To: Development Permit Panel
From: Joe Erceg
Manager, Development Applications
Date: October 8, 2002
File: DP 02-205966
Re: **Application by Westbank Projects Corporation for a Development Permit at
11760 Steveston Highway**

Staff Report

Site
Plan

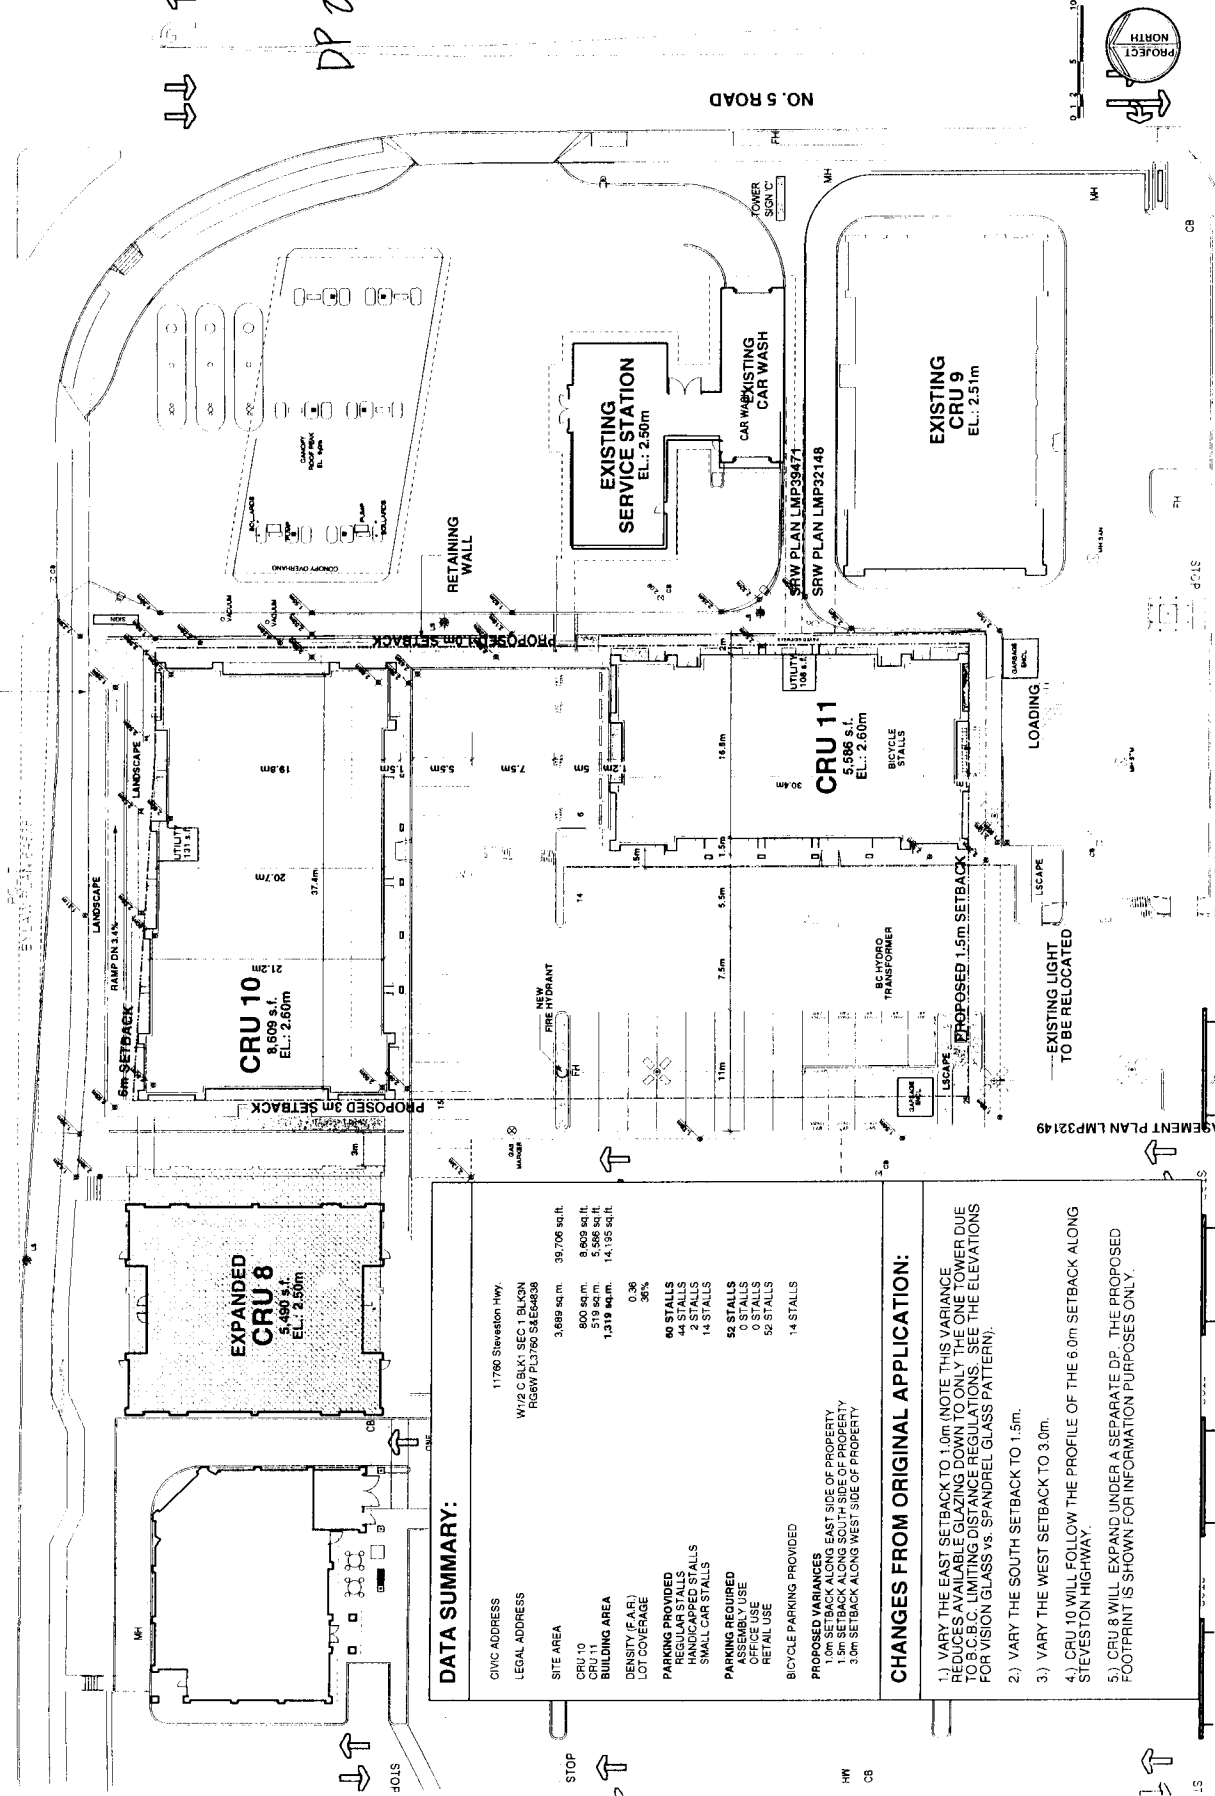
1. Please provide an explanation as to how loading would be accommodated on the subject site. ***A loading area has been delineated for CRU 11.***
2. Screening of the refuse container at the southeast corner of the site. ***The applicant has indicated that the screening of the proposed refuse container will be treated in the same manner as other containers in the Ironwood Plaza parking lot.***

6. The extent of the building overhang(s) should be shown on the site plan. ***Overhang extents have been shown.***
7. Major pedestrian connections through the parking area should be raised. ***Major pedestrian connections are raised.***

3. Improve on-site pedestrian circulation, including a new accessible pedestrian connection between the boulevard along Steveston Highway and the site and consider a pedestrian link with the Chevron Station immediately to the east. ***A ramp to Steveston has been provided. A pedestrian connection to the Chevron building has been provided.***

1. Raise the major pedestrian link across the main east-west internal road to the south of the subject site. ***The pedestrian link along the main east-west access has been raised.***
2. Provide a turnaround capability for the parking stalls at the east side of the site. ***Provisions for vehicle egress have been provided.***

L1

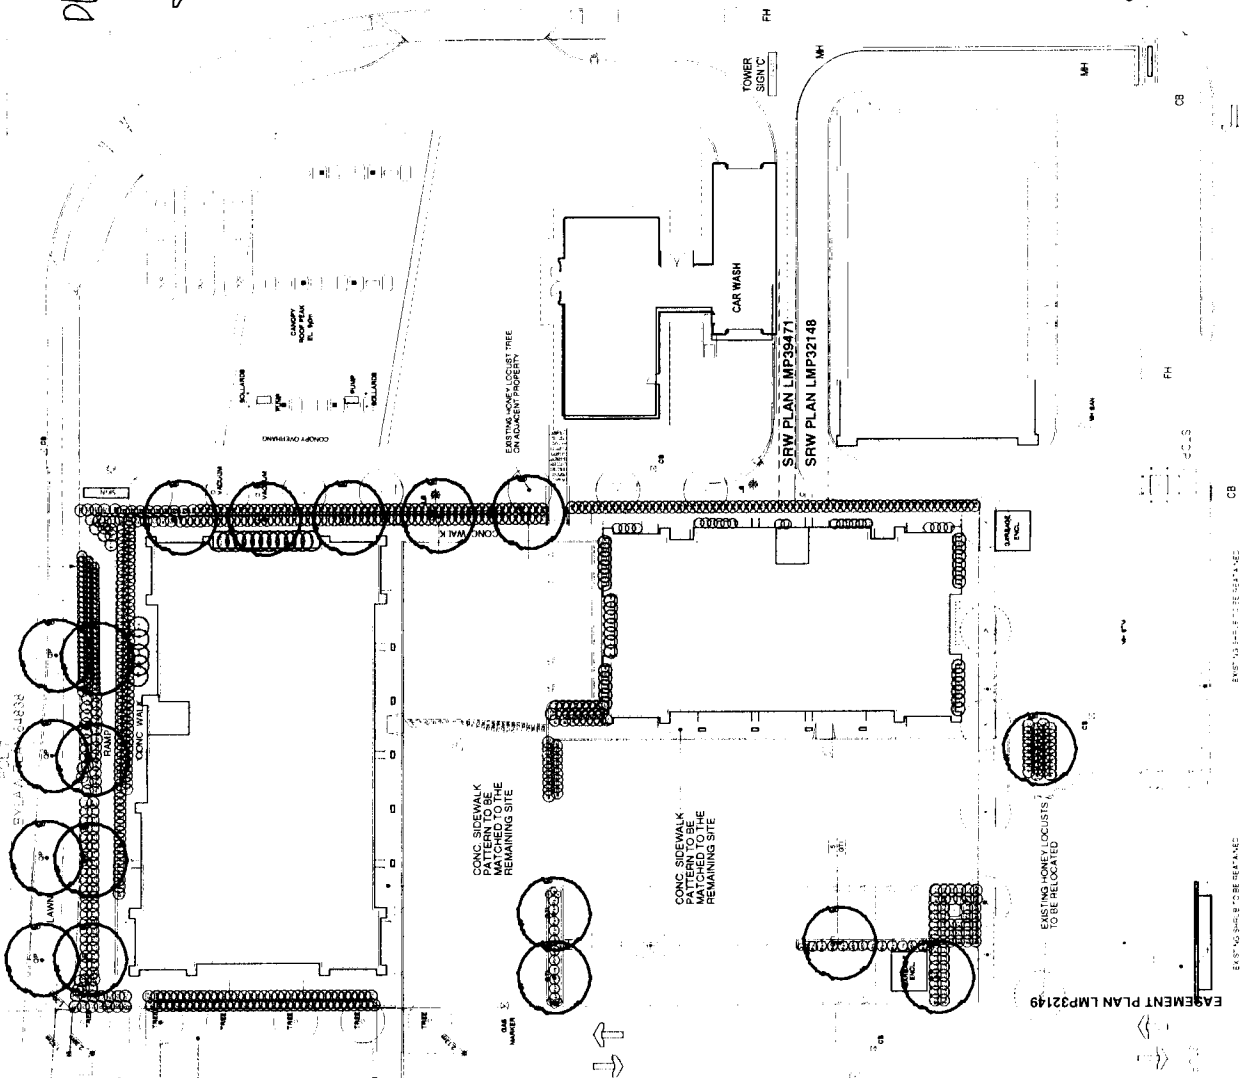
4. Provide a row of trees along the east property line at a minimum caliper size of 10 cm (4 inches). ***We have provided a row of trees along the eastern edge as requested.***

8. Provide an additional two (2) Skyline Honey Locust trees at 8.0 cm caliper size along the east property line in the opening between the subject site and the Chevron Service Station to the east. This issue has been discussed and supported by Chevron. ***The applicant has complied.***

CRU 10
Elevations

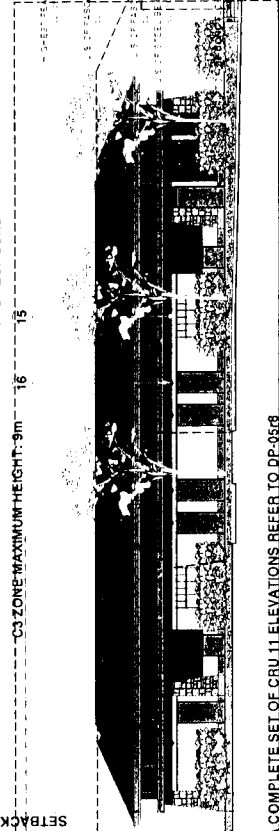
9. Provide spandrel glass panels along the north elevation of the CRU 10 (i.e. the Steveston Highway streetscape) and ensure that at least 60% of this building elevation is glazed. ***The applicant has complied and provided additional glazing along the north elevation of CRU 10 to the satisfaction of Richmond staff.***

10. Provide spandrel glass panels between the buttresses on the east elevation of CRU 10 at the southeast corner of the building. ***The applicant has complied.***

CRU 11 Elevations

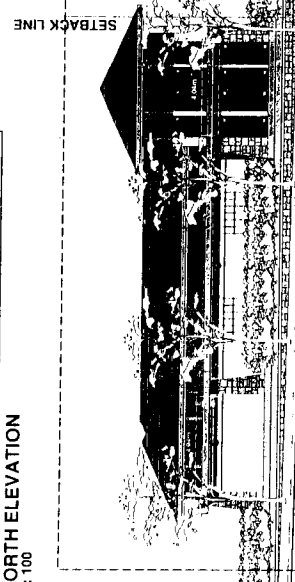
11. Provide spandrel glass panels between the buttresses at the northeast corner of CRU 11. ***The applicant has complied.***
12. Eliminate the requested variance along the east property line or negotiate an acceptable compromise with the neighbouring property owner to the east (i.e. the Chevron gas station at the southwest corner of No. 5 Road and Steveston Highway). ***The revised design requires an increased setback variance along the east property line of the subject site. However, the applicant has recently met with representatives from Chevron and it is now the understanding of Richmond staff that the current proposal meets with the approval of Chevron, the property owner to the east of the subject site.***
